**NOTICE
OSHTEMO CHARTER TOWNSHIP
Zoning Board of Appeals**

**Tuesday,
September 27, 2016
3:00 p.m.**

Request: Site Plan Review

Project Name: National Flavors

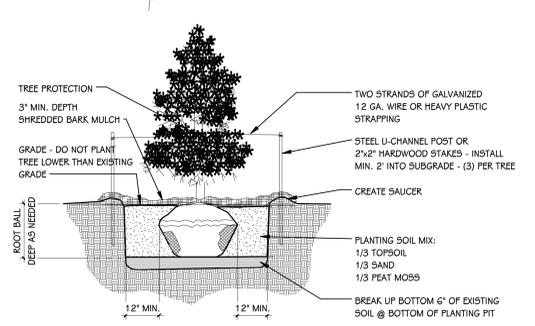
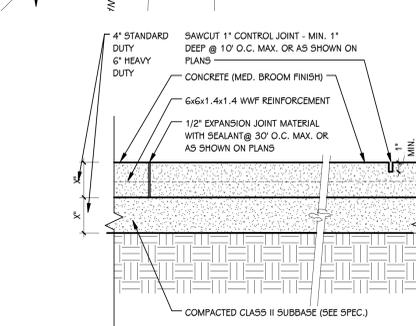
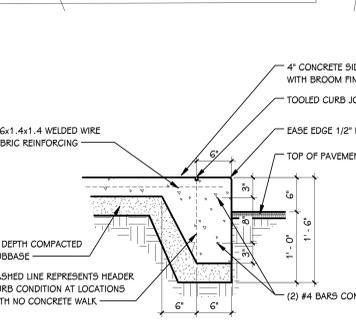
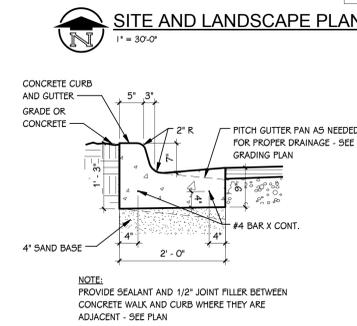
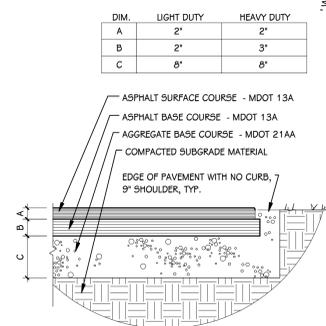
Overall, the landscape plan meets the requirements of *Section 75: Landscaping*. However, *Section 75.180: Material requirements and maintenance* states that at least 75 percent of the canopy trees on the site must be native to Lower Michigan. While the total number of required canopy trees have been provided, the percentage required to be native has not been met. A revised landscaping plan will be needed.

1. Final storm water volume calculations are to be provided to the Township Engineer for review, as well as any final engineering concerns addressed.
2. A revised landscape plan provided prior to the issuance of a building permit that meets the requirements for 75 percent native canopy trees.
3. The northern most drive aisle will be changed from 20-feet to 24-feet to better accommodate fire safety equipment.
4. A final review of the site plan by the Fire Marshal and a revised plan if requested changes are made to the location of fire hydrants.

SHEET TITLE
UTILITY PLAN

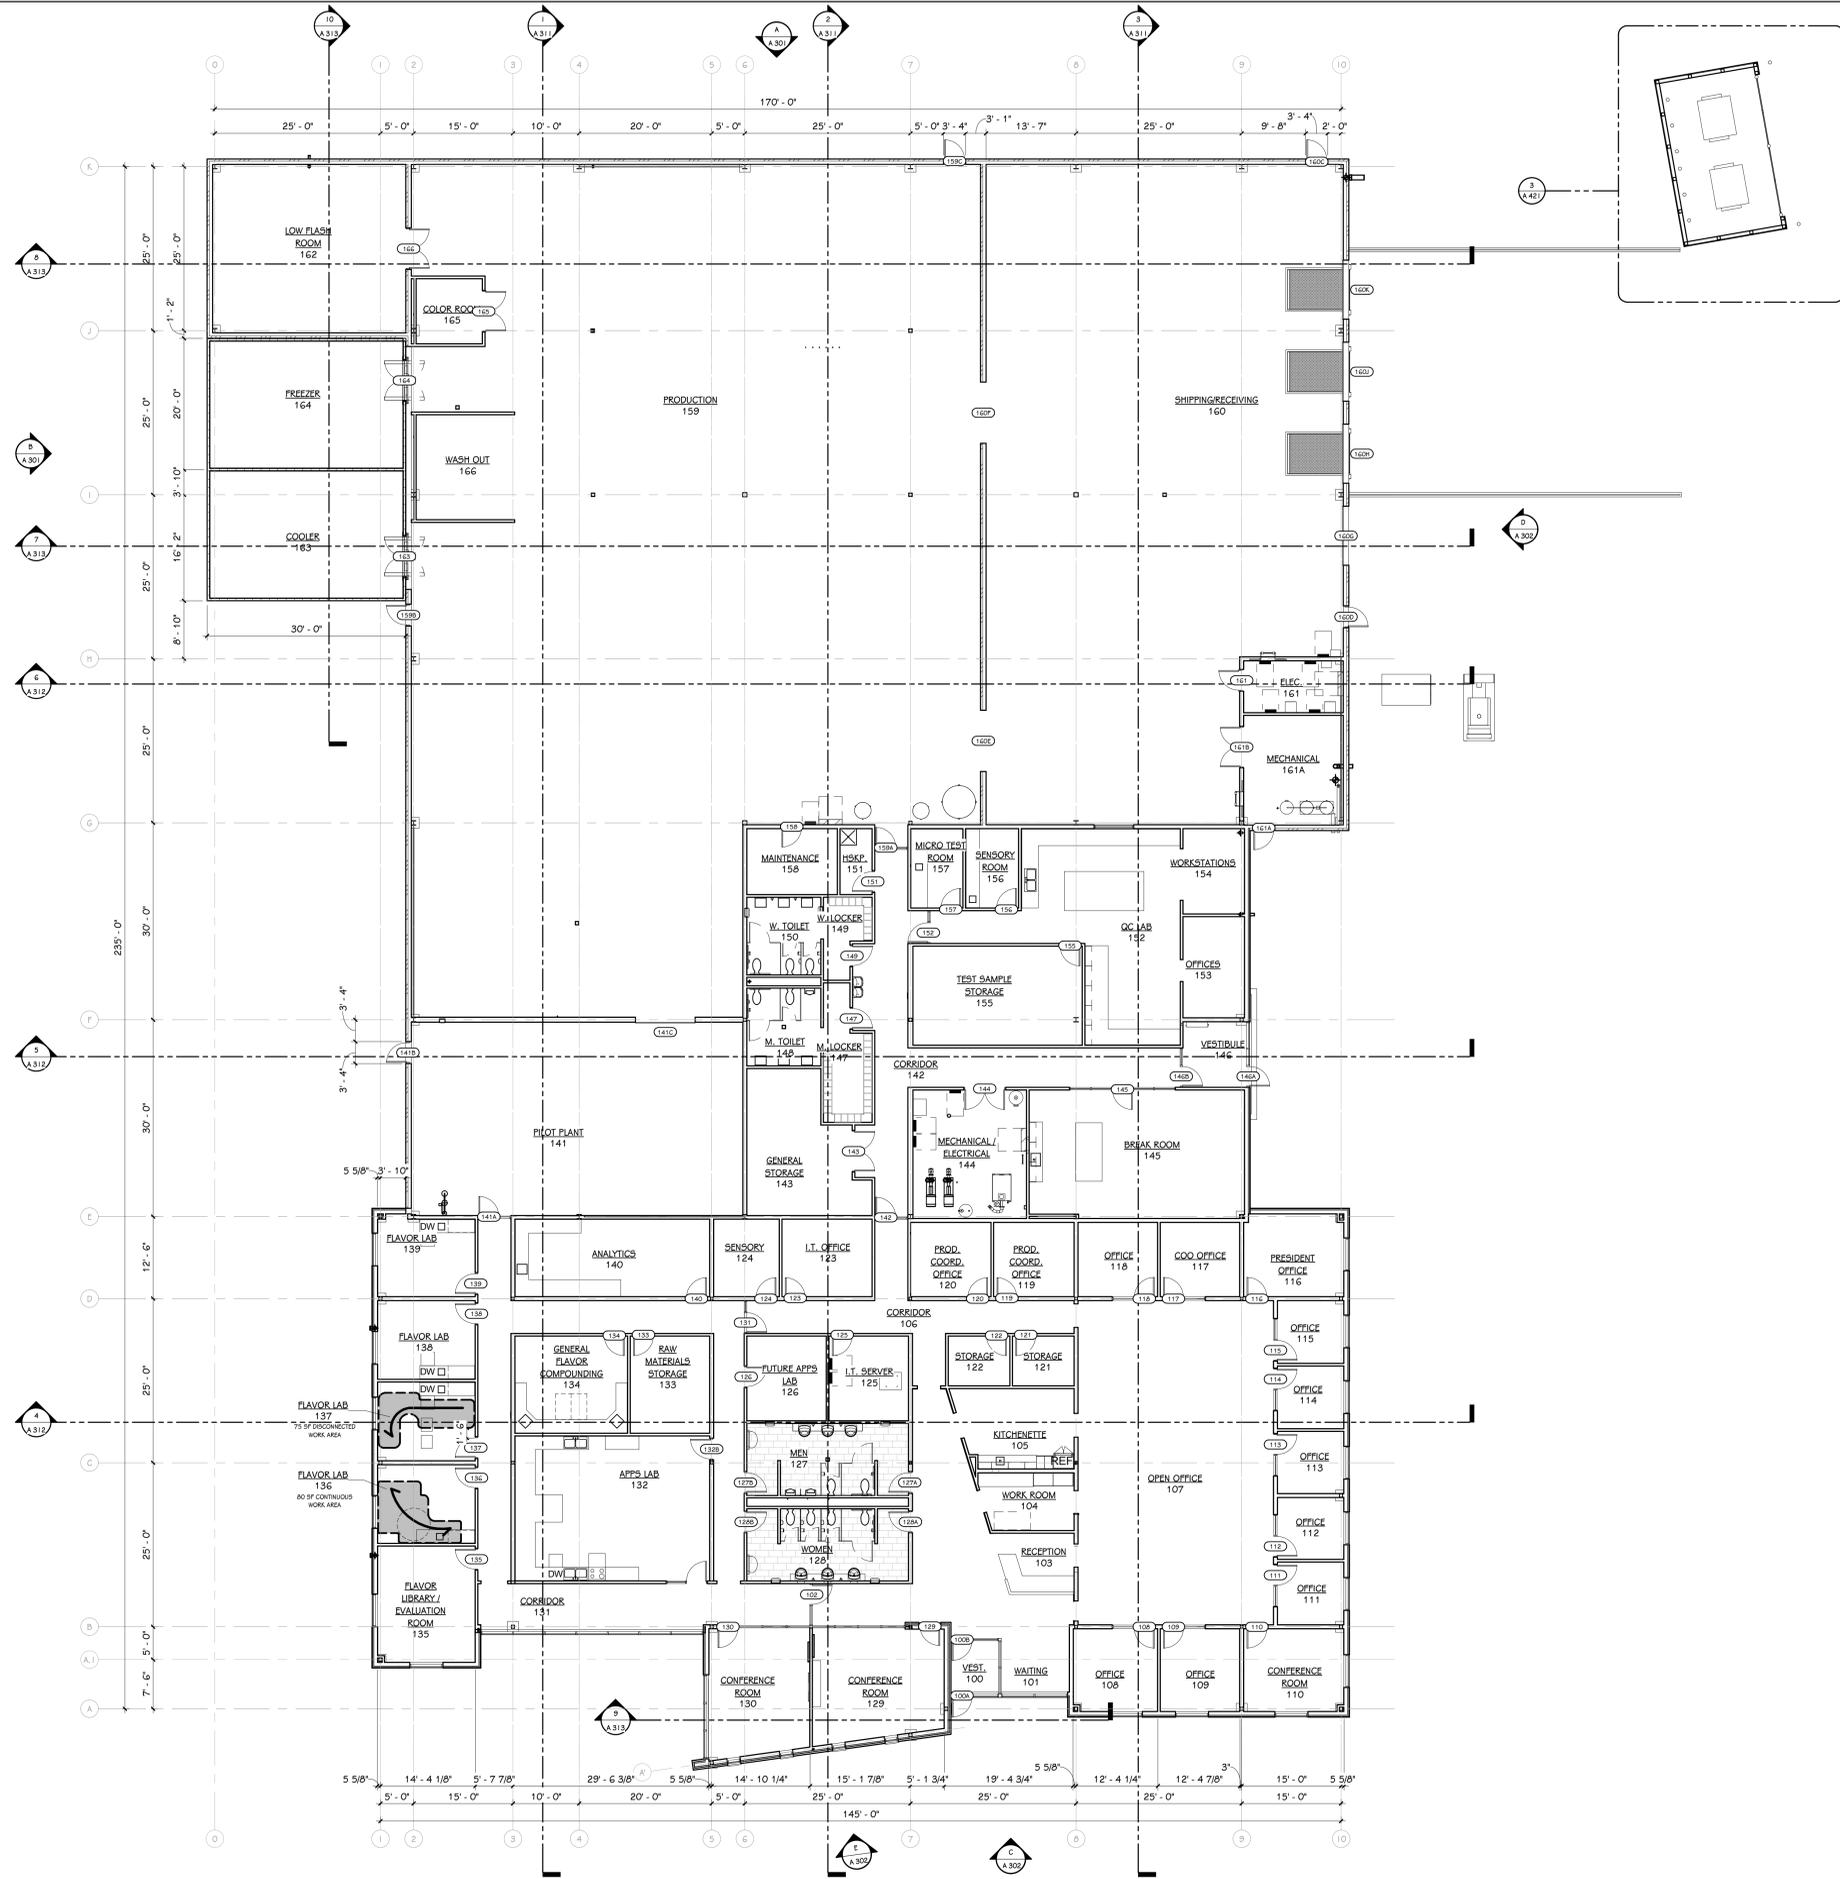
The Township Engineer states that the project is generally buildable, but still needs to better understand the storm water volume calculations provided by the applicant. This will need to be resolved prior to the issuance of a building permit.

Wendy's, 5455 West Main
Current Surrounding Land Uses

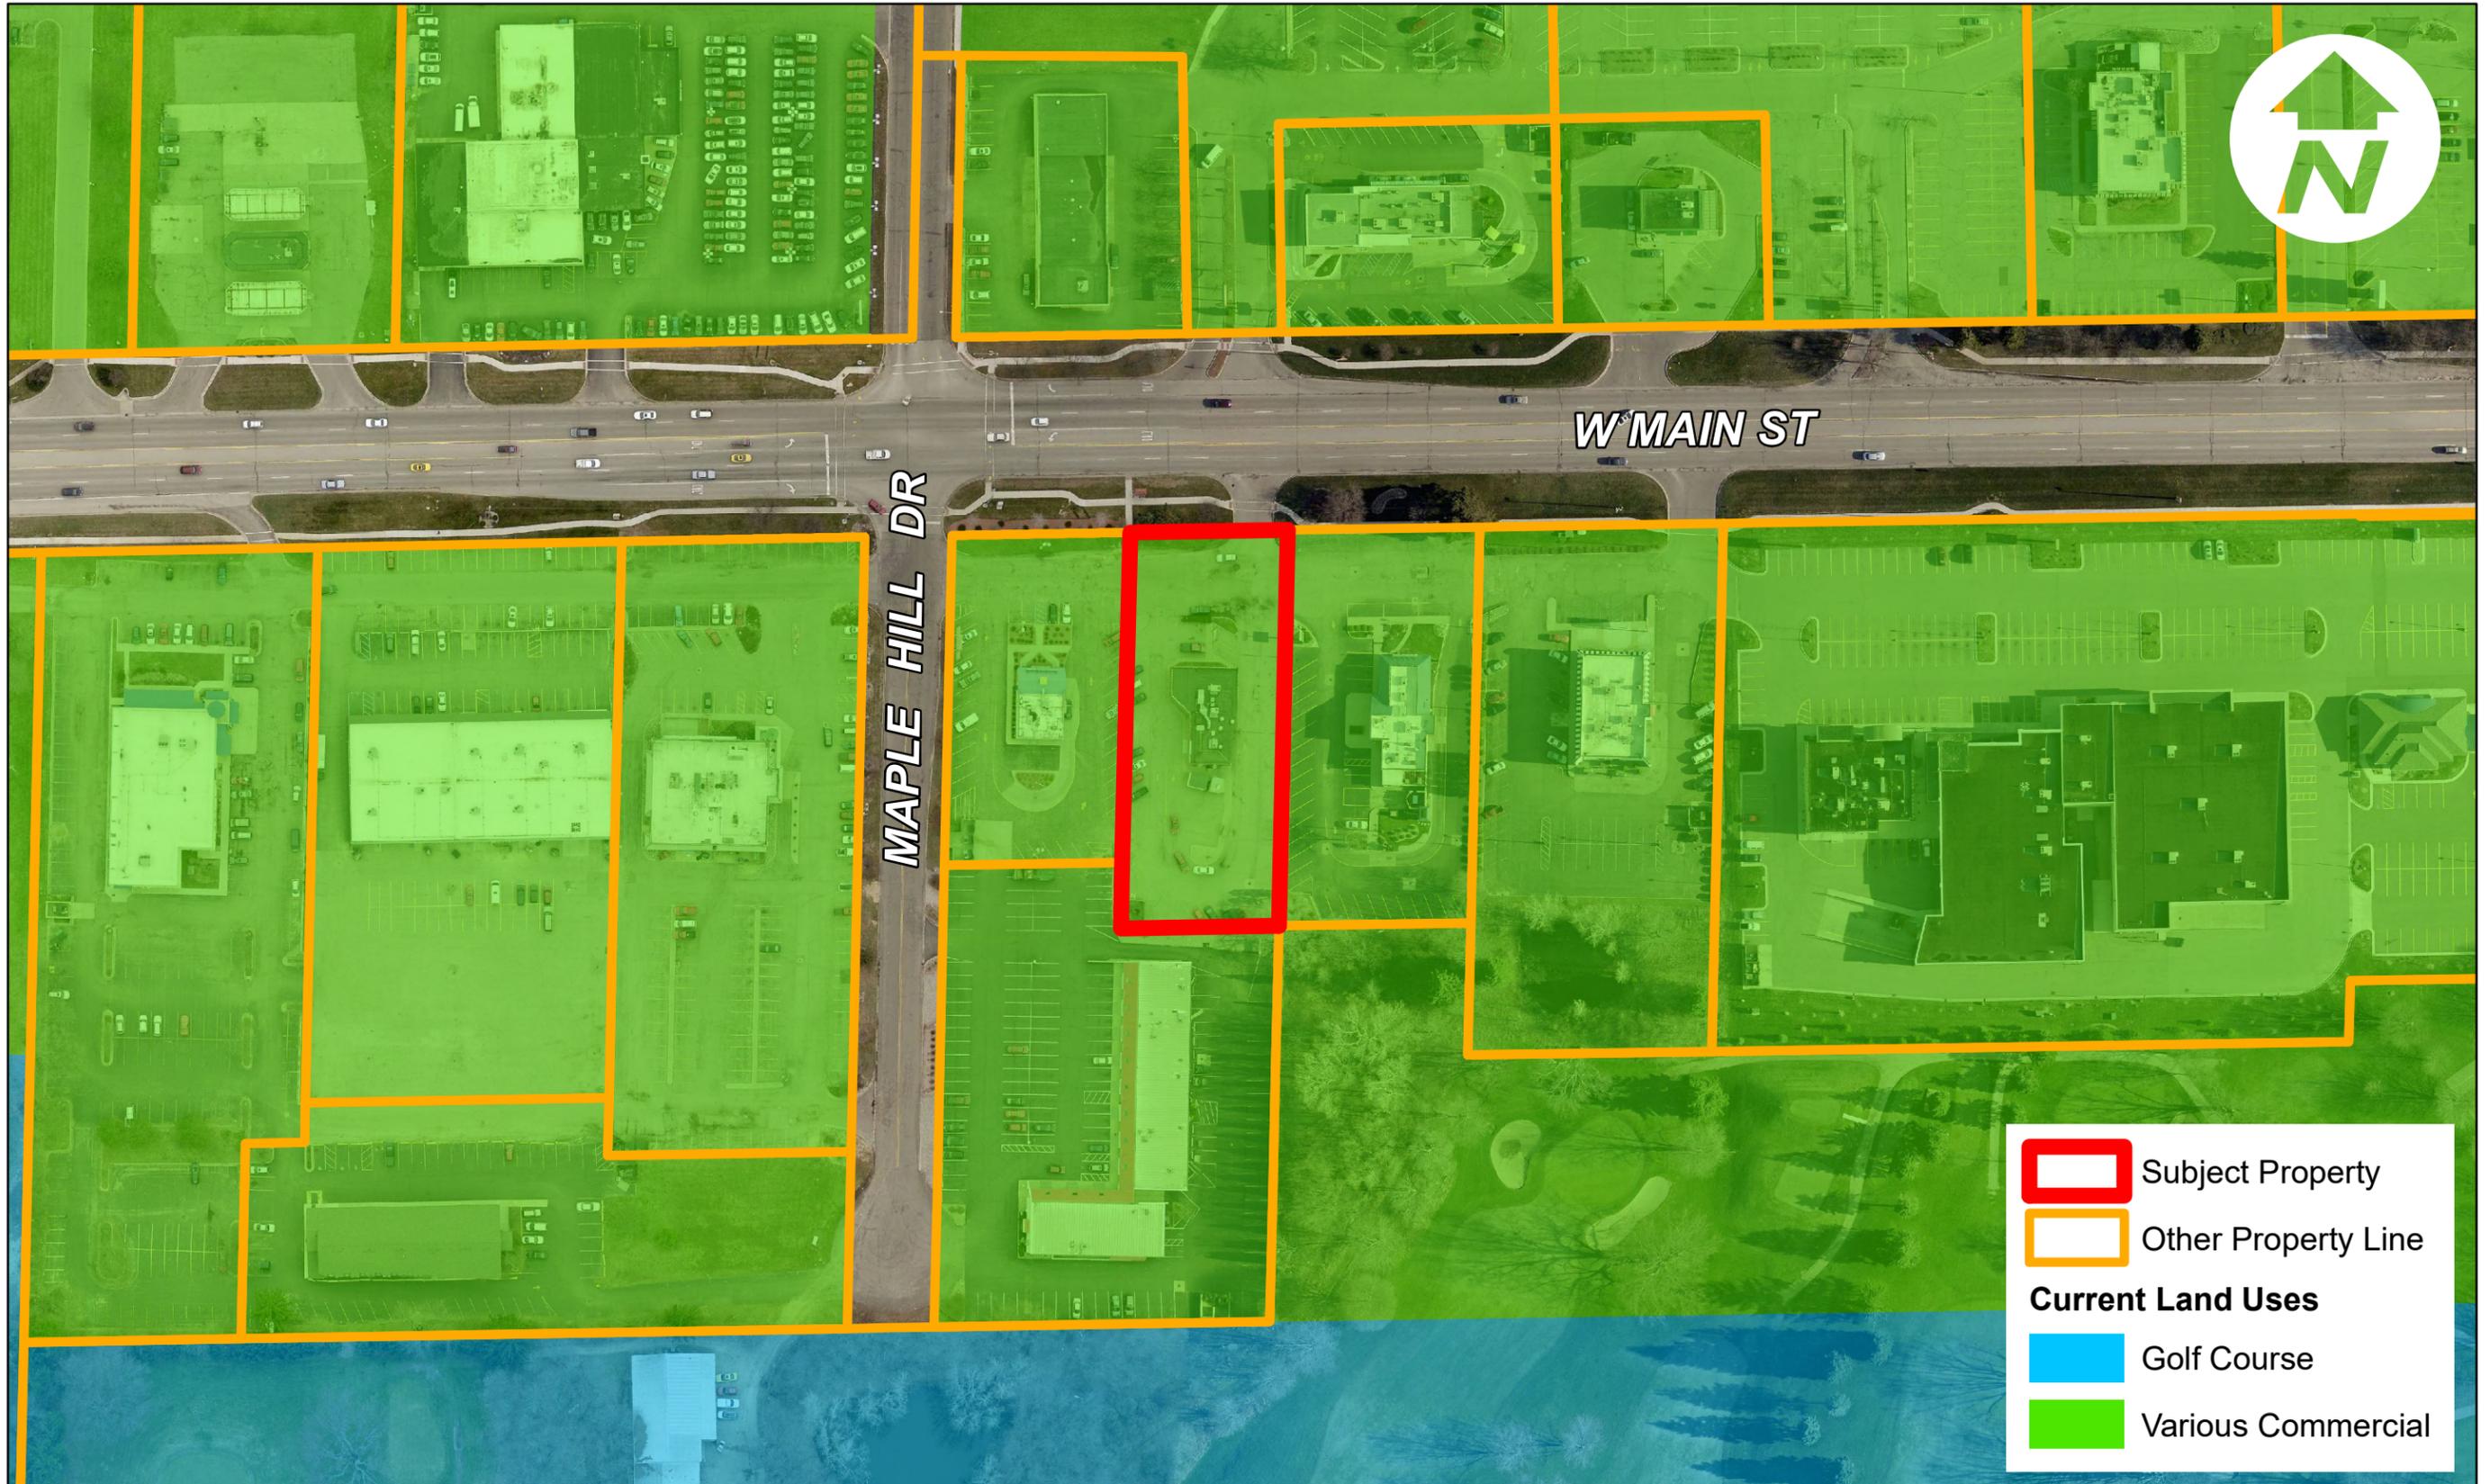
Comment: The Wendy's property is only 120 feet wide, which is the narrowest lot within the Elk's Plat. In addition, it is narrower than many of the other commercially zoned properties in the Township. This unique physical characteristic is making compliance with the 0.1 footcandle requirement exceedingly difficult to meet.

XGBM LED Area Light

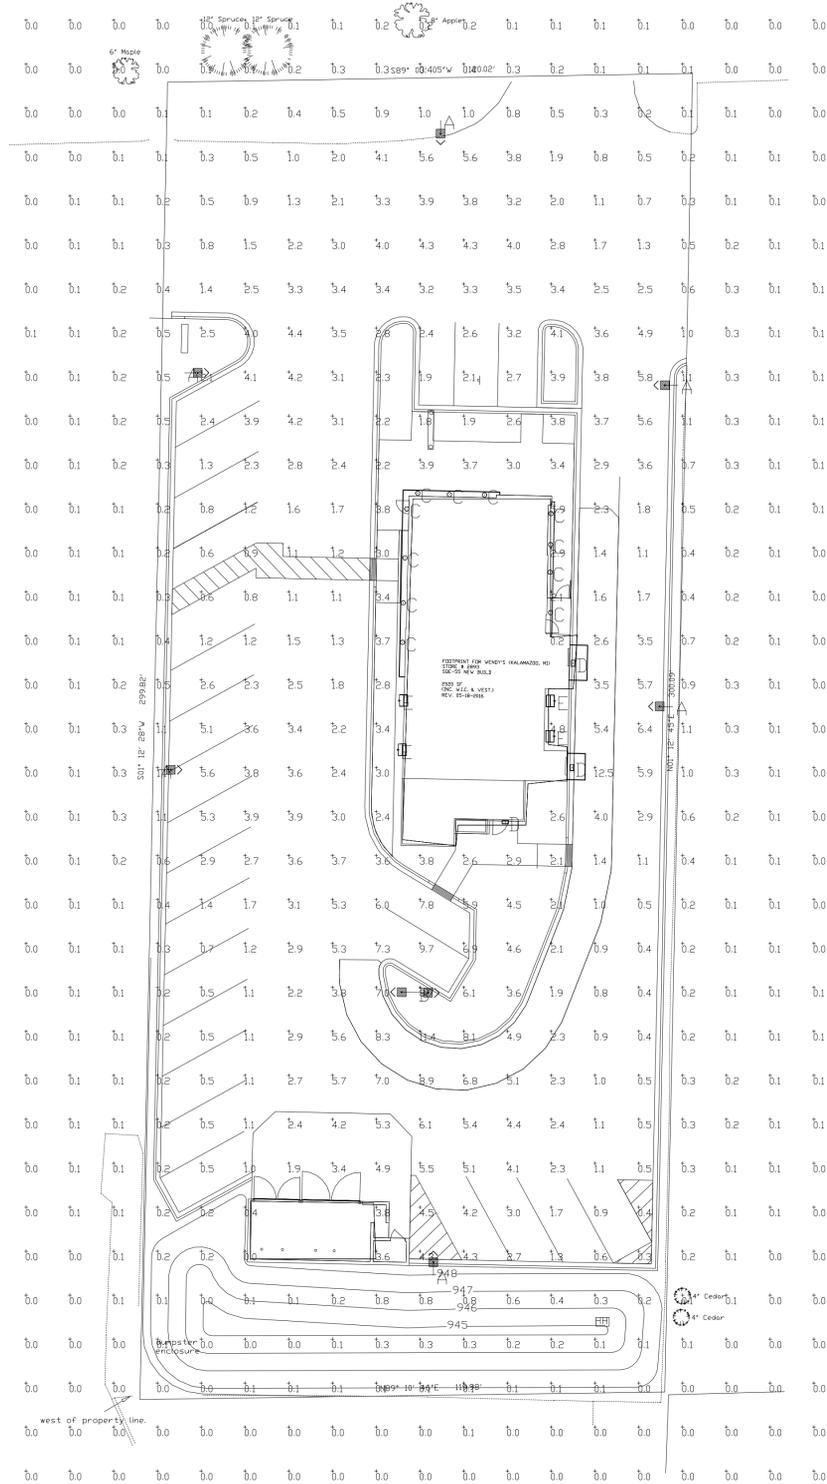
As can be seen on the attached photometric plan, the proposed indicated light levels exceed 0.1 foot-candles along the north (maximum of 0.4 foot-candles), east (maximum of 1.1 foot-candles), and west (maximum of 1.1 foot-candles) property lines. Light levels at the south property line are in compliance with the Zoning Ordinance. Although light levels at the parcel boundaries are in excess with what the Township typically allows, all other aspects of the lighting plan are compliant, including wattage outputs, pole heights, and cut-off light fixtures.
